Access Compliance Report Public Rights-of-Way (Pedestrian Signals)

Main Street: IRVINE_BLV D Cross Street: RED_HILL_AVE Location: SW

ADA ID: SGAT211027090737 Signal Type: One Push Button-APS Overall Compliance: No Severity Scores: BTN 1: 25 BTN 2: N/A No BTN: N/A

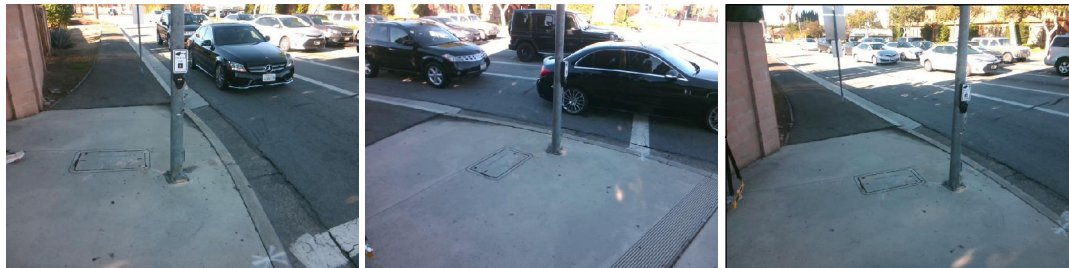
Possible Solutions: Remove and Replace Clear Space.

OC Std/PROW: R404.2, R404.3
